DATE	REV	DESCRIPTION
12/12/2019	A	DA ISSUE
25/05/2020	B	DA ISSUE - EX. GROUND LEVEL INFORMATION ENHANCED AS REQUIRED BY COUNCIL

PROJECT
41 & 43 BEACH ROAD COLLAROY
LO1 1 DP300846 AND LOT 2 SEC 7 DP7391

DRAWING NO.
DA 100

DRAWING TITLE	SCALE:	DRAWING NO.
			EX. AND PROPOSED RL ANALYSIS AGAINST DCP AND LEP REGULATIONS SOUTH EAST AREA DETAIL			1:100 at A1 & 1:200 at A3	DA 106

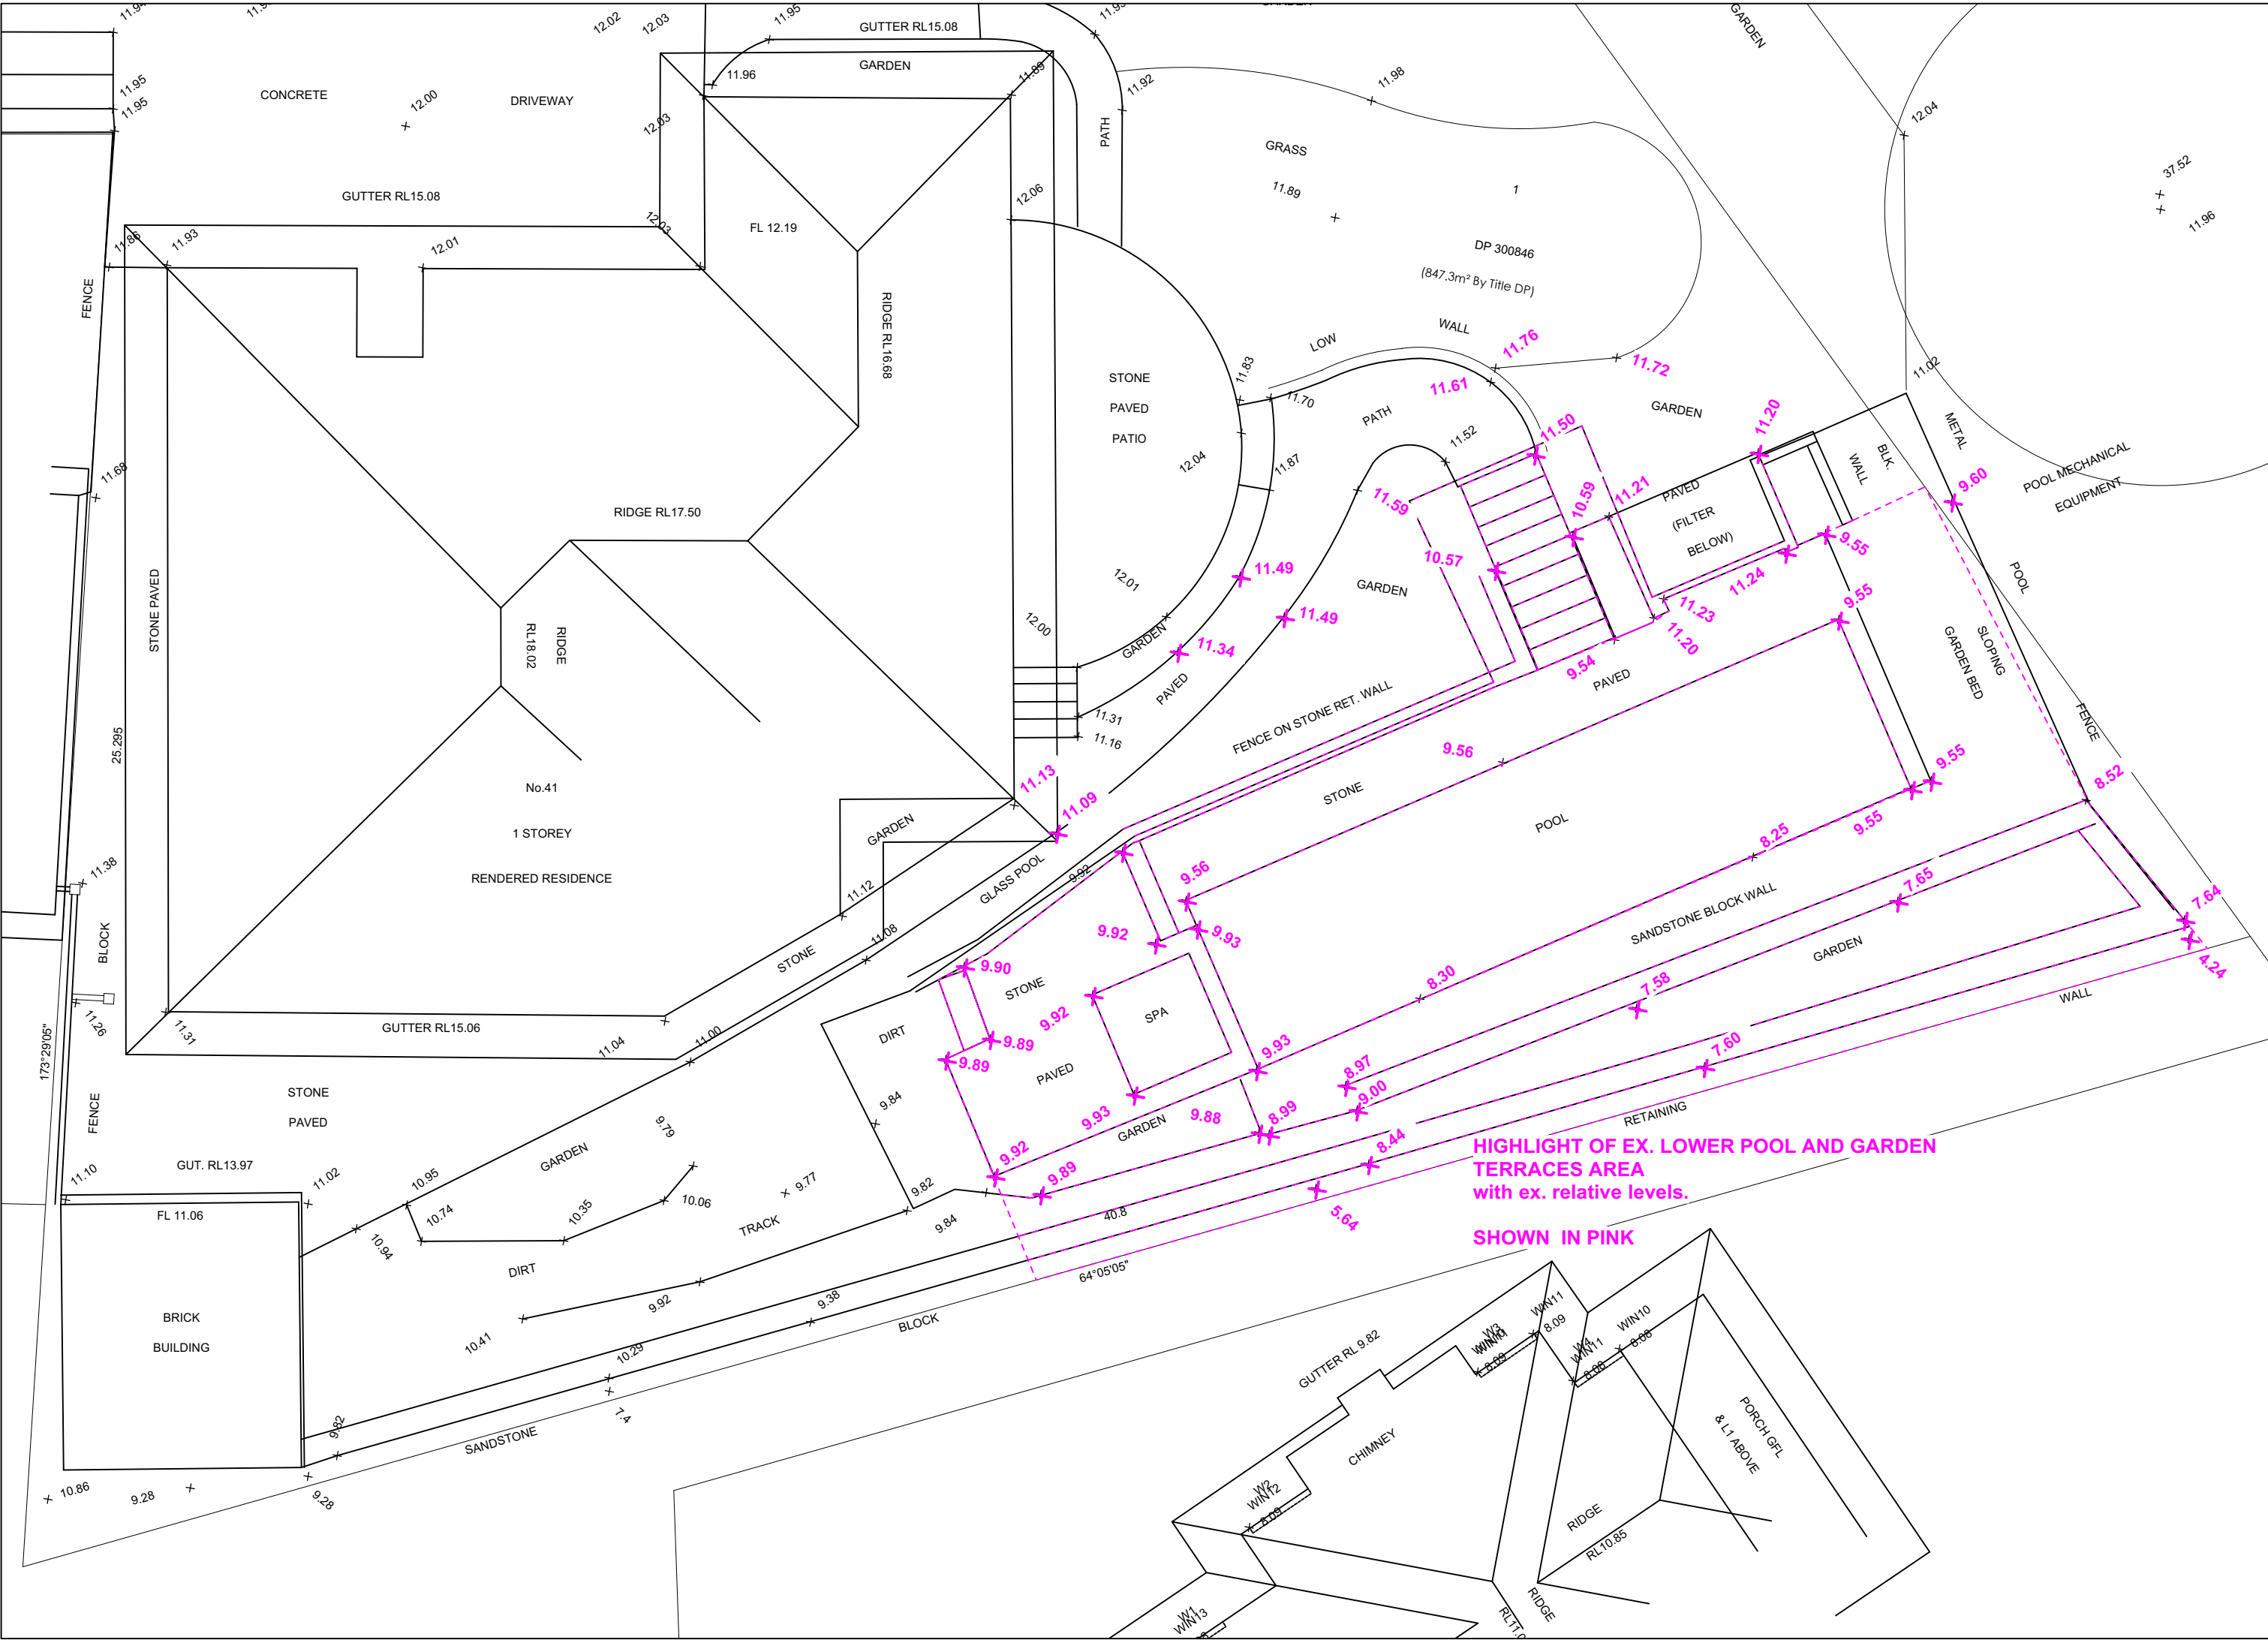
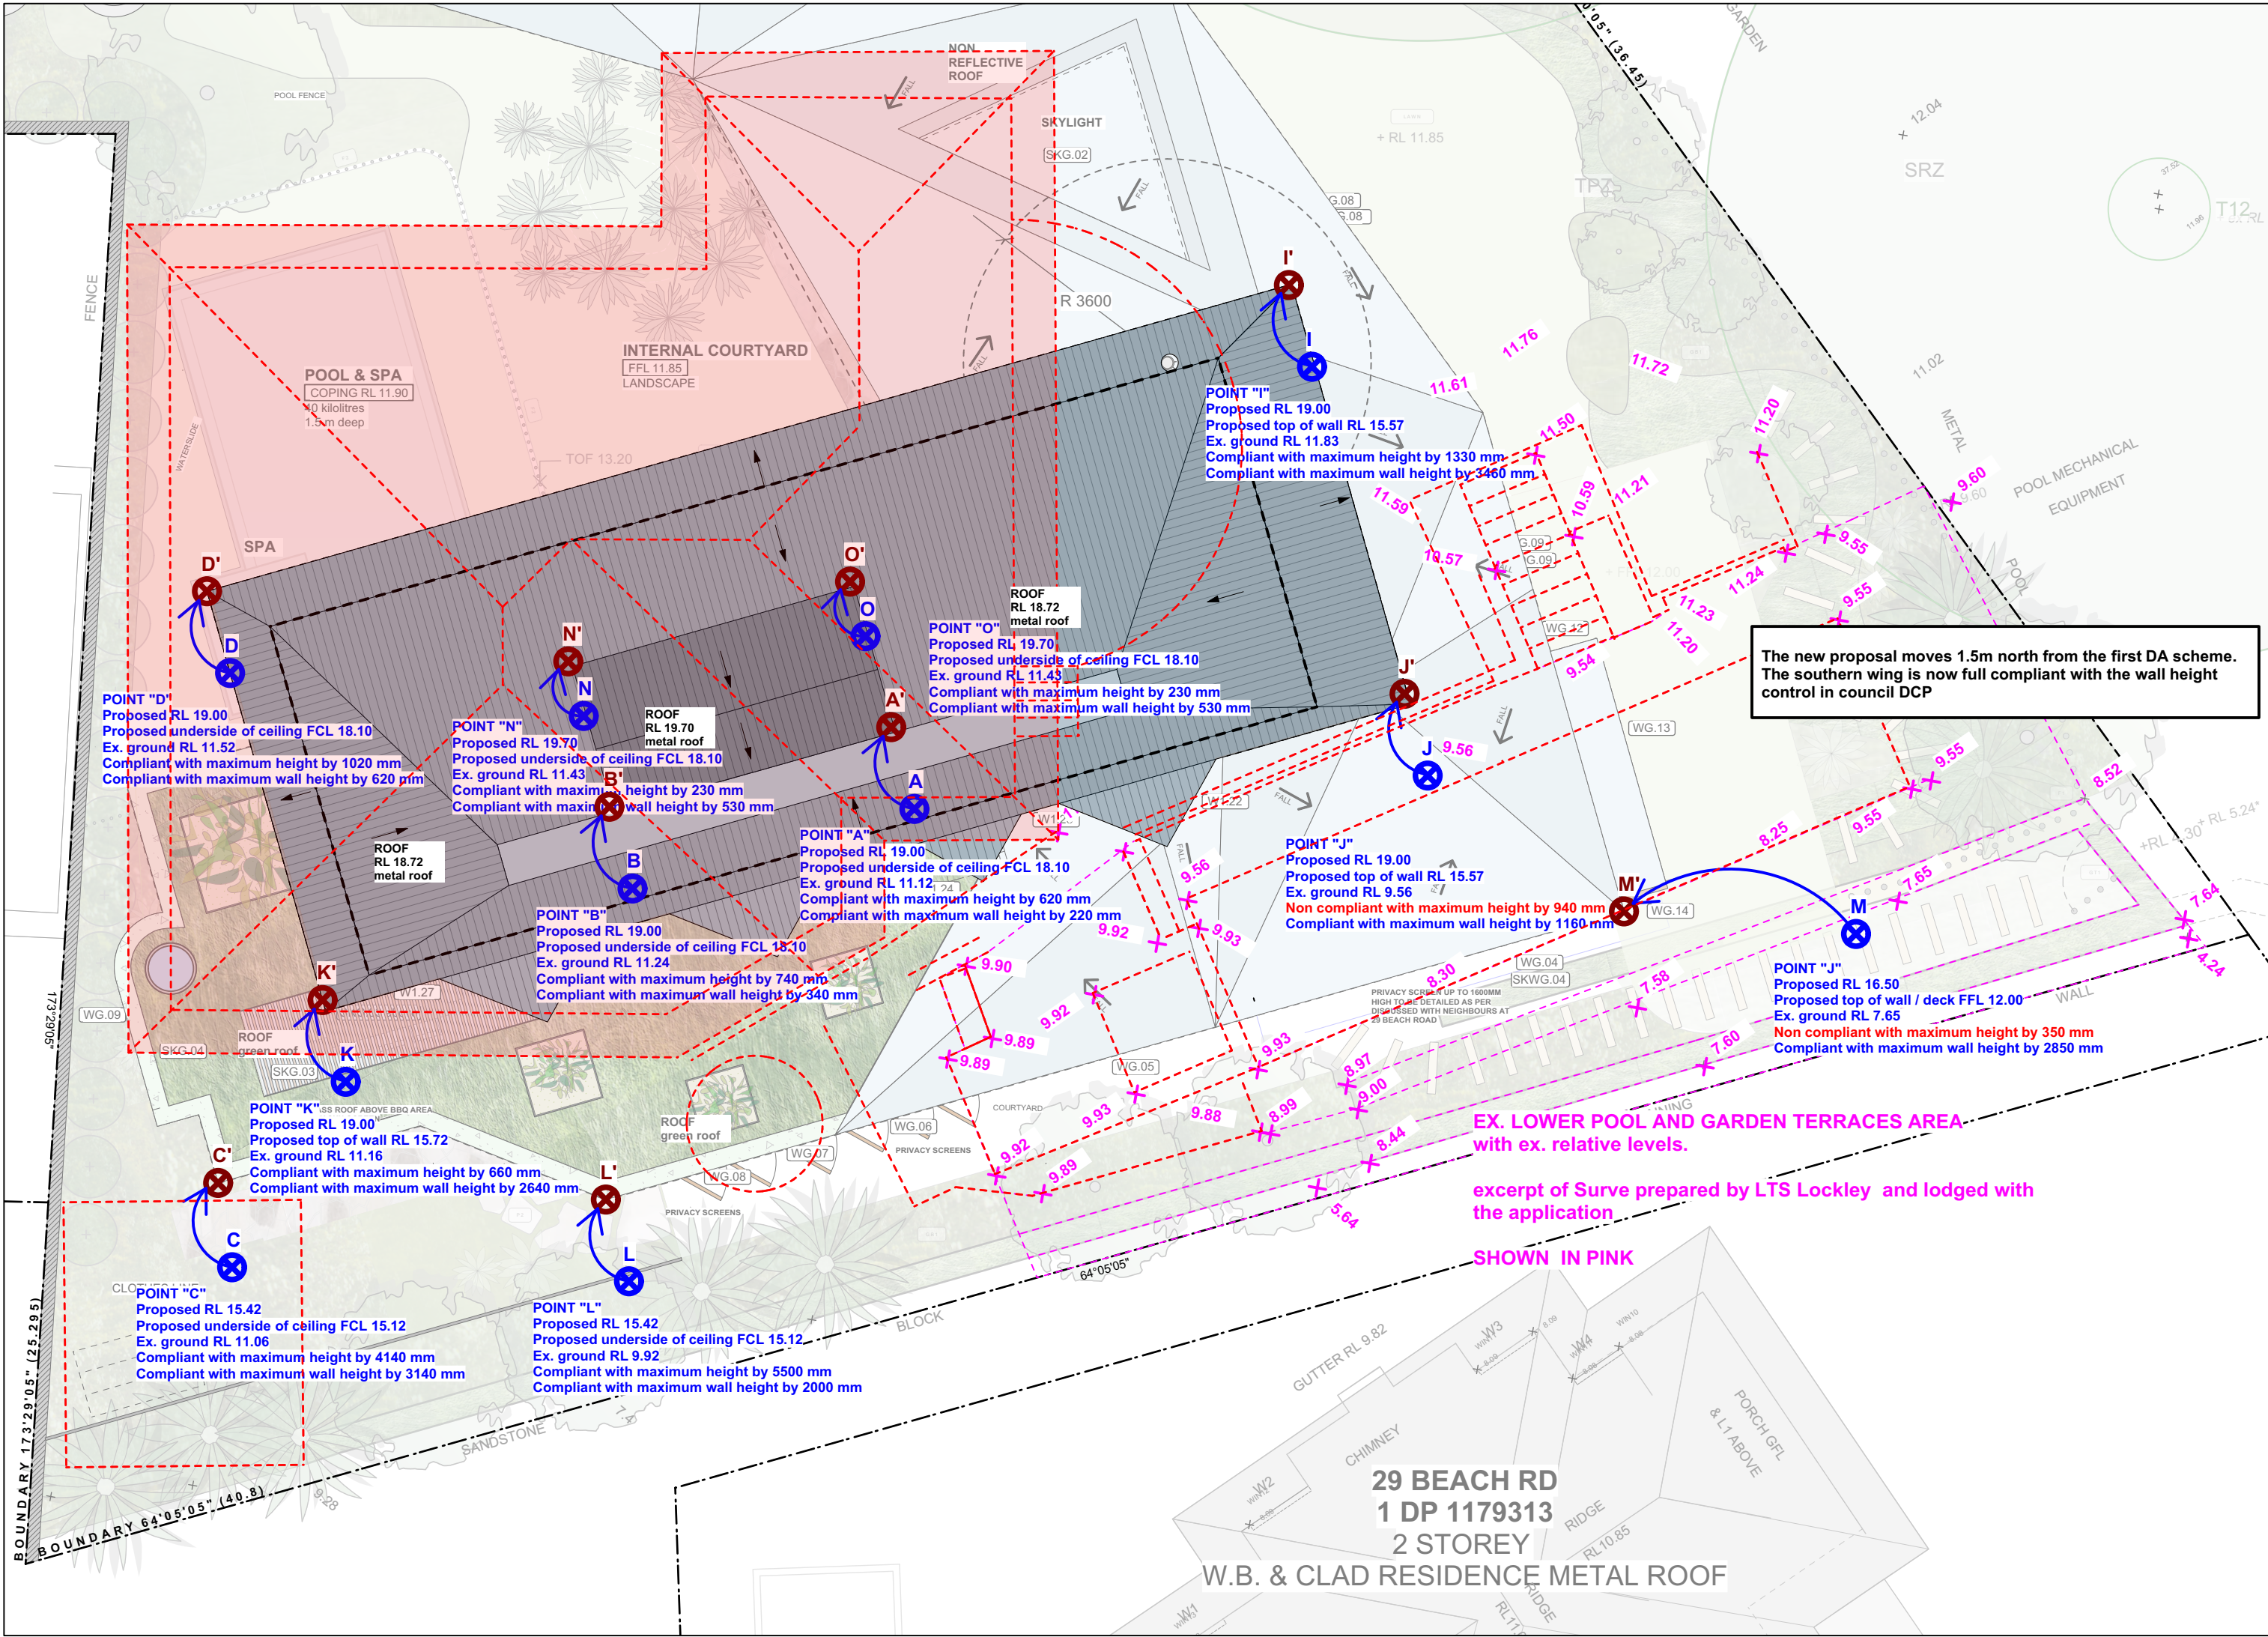
Notes:

- Warringah LEP 2011 allows a Maximum Building Height of 8.5 m above existing ground level.
- Clause B1 "Wall Heights" of Warringah DCP 2011 states:
"Walls are not to exceed 7.2 metres from ground level (existing) to the underside of the ceiling on the uppermost floor of the building (excluding habitable areas wholly located within a roof space)."
- Clause B1 of Warringah DCP 2011 states:
"Walls are not to exceed 7.2 metres from ground level (existing) to the underside of the ceiling on the uppermost floor of the building (excluding habitable areas wholly located within a roof space)."

The proposal has been assessed in detail against the regulations above.

With the south wing moving 1.5m away from the southern boundary, and additionally lowering the roof by 280mm, the south wing is now compliant with council regulations.
